Section 11: Generator Data Confidentiality Procedures

11.1 Generator Data Confidentiality Procedures

11.1.4 Generator Data Process Flow

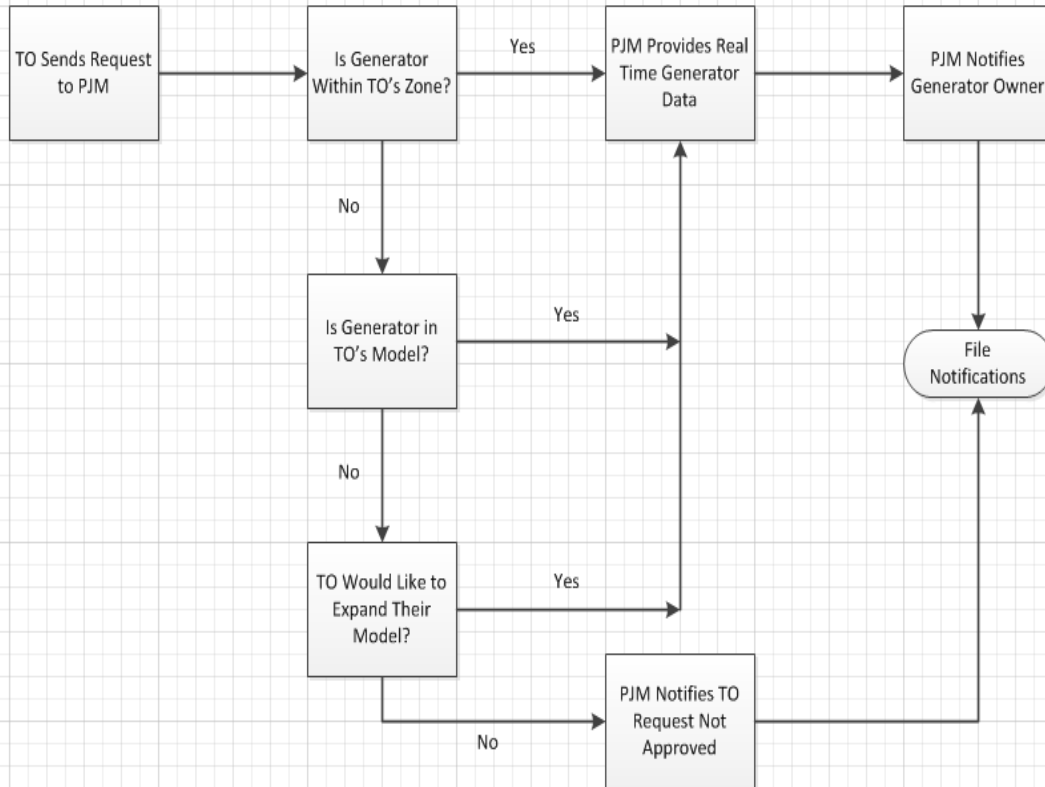
~~11.1.6 PJM Evaluation of Data Request~~

~~Annually, PJM will send a list to the Generator Owners stating their data that is being sent to each Transmission Owner. The Generator Owner may challenge this data release by using the dispute resolution process.~~

~~The Transmission Owner must provide the decision point under which they believe their request qualifies, and if requested, provide supporting information to PJM and the Generator Owner. If requested by a Generator Owner, PJM will evaluate the technical merits of the request using the PJM-EMS model.~~
